Response to Commissioner Questions

The following is in response to the further information and specific questions asked by the Hearing Commissioner in Section 2 of Minute 1 issued 10 May 2022. I copy the questions in italics and provide my response below.

Figure 1: General distinction between flat and upper slopes (red) and steep lower slopes (blue).

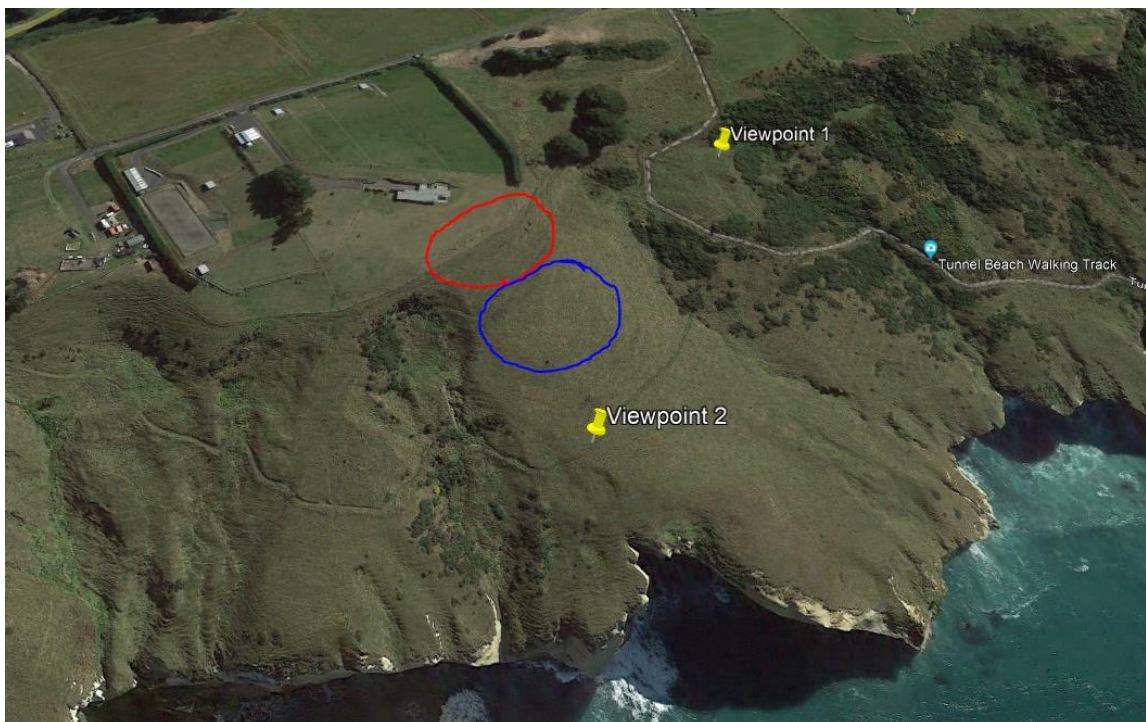
12. When assessing the potential effects of the proposed walkway there are notable differences in the nature and sensitivity of the elevated, flat pastureland where Ms Durling has taken photos from, which includes the immediately adjacent hill slope and the steeper hill faces that slope away to the southernmost property boundary. An indication of these areas are shown in red and blue below:

13. In my view the **flat areas to the south of the existing dwelling exhibit a moderate high sensitivity to change**, owing to their proximity to outdoor living areas and use for grazing and working horses. As Ms Durling has indicated in her evidence these areas are regularly used and enjoyed.

14. Conversely **the steep hill faces to the south exhibit a lower level of sensitivity to change** because they aren't accessed, used, and enjoyed in the same manner and frequency as the flatter land to the north. Clearly there is nothing stopping Ms Durling and her partner from accessing this land and potentially standing in relative proximity to the proposed walkway and Viewpoint 2. However, I think the fact that Ms Durling has emphasised (in text and photos) the importance of the flat pasture land to the north and said very little about the potential visual effects on steeper hill faces to the south emphasises the difference in sensitivity to change between these areas.

Figure 2: Additional planting adjacent to Viewpoint 1

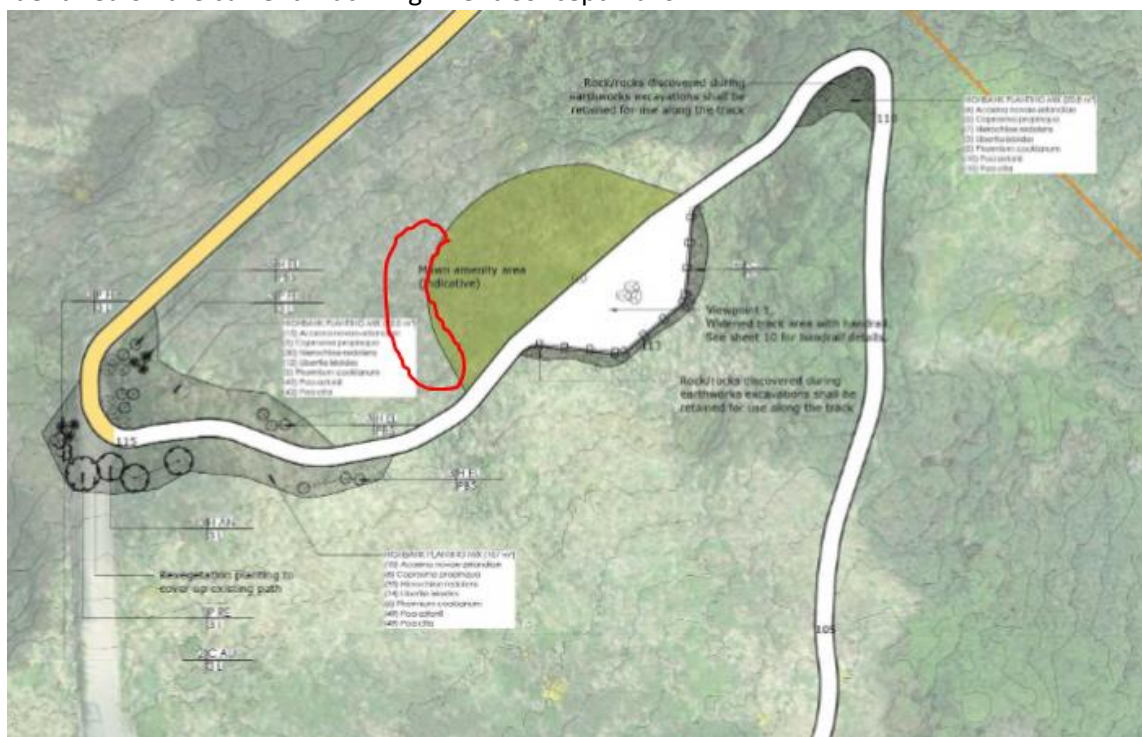
32. Despite a relatively low degree of effect, and certainly less than significant, I do see benefit in additional planting being undertaken in the indicative areas shown in Figures 2 – 4 below and recommend the Crown consider this assessment in their development plans. The purpose of this planting is not necessary to achieve the 'less than significant' test in s4(3), rather it is to respond to the perceived impacts of the proposal on Ms Durling and her property and to provide screening of the proposed works.

33. In my opinion 'block planting' of predominantly ngaio (*Myoporum laetum*) would be the most effective approach to achieving a visual screen in these locations. It is widespread on the coastal hill faces and grows to a favourable height and density. There is also potential to supplement with other lower growing species so these areas are consistent with the 'Highbank Planting Mix' identified on the current Track Alignment Concept Plans.
